Access Compliance Report

Public Rights-of-Way

(Curb Ramps)

Intersection ID: 26392	Main Street: BEVINGTON_PL	Cross Street: BRECHIN_DR	Location: S
ADA ID: 453B2CB2C5C5	Ramp Type: Perp	Initial Pass/Fail: Fail	Overall Compliance: No
Codes/Mitigation Info/Possible Solution		Field Measurements/Component Compliance	
Severity Score: 26.25

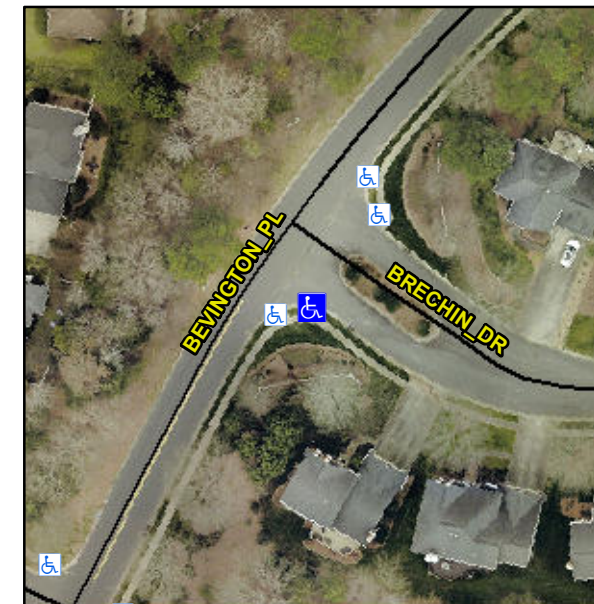
Not Found, R304.2.2, R304.5.3

Compliance	Description	Data	Compliance	Description	Data
N/A	Ramp Length (in)	46.0	No	Ramp Slope (%)	12.2
Yes	Ramp Width (in)	48.0	No	Ramp XSlope (%)	2.4
N/A	Flare Type LT	N/A	N/A	Flare Type RT	N/A
N/A	Flare Slope LT (%)	N/A	N/A	Flare Slope RT (%)	N/A
N/A	Flare Traversable LT?	N/A	N/A	Flare Traversable RT?	N/A
N/A	Landing Length (in)	N/A	N/A	DWS Provided?	N/A
N/A	Landing Width (in)	N/A	N/A	DWS Contrast?	N/A
N/A	Landing Slope (%)	N/A	N/A	DWS Length (in)	N/A
N/A	Landing X Slope (%)	N/A	N/A	DWS Full Width?	N/A
N/A	Landing Curb? (Y/N)	N/A	N/A	DWS Offset (in)	N/A
N/A	Shared Landing?	N/A			
N/A	Gutter Ponding?	N/A	N/A	Gutter Slope (%)	N/A
N/A	Gutter Lip Ht (in)	N/A	N/A	Gutter X Slope (%)	N/A
N/A	Painted X Walk1?	No	N/A	Painted X Walk2?	N/A
	X Walk 1 Direction	To NE		X Walk 2 Direction	N/A
N/A	X Walk 1 Width (in)	N/A	N/A	X Walk 2 Width (in)	N/A
	X Walk 1 Slope (%)	1.2		X Walk 2 Slope (%)	N/A
	X Walk 1 X Slope (%)	3.6		X Walk 2 X Slope (%)	N/A

Remove & Replace Entire Ramp.
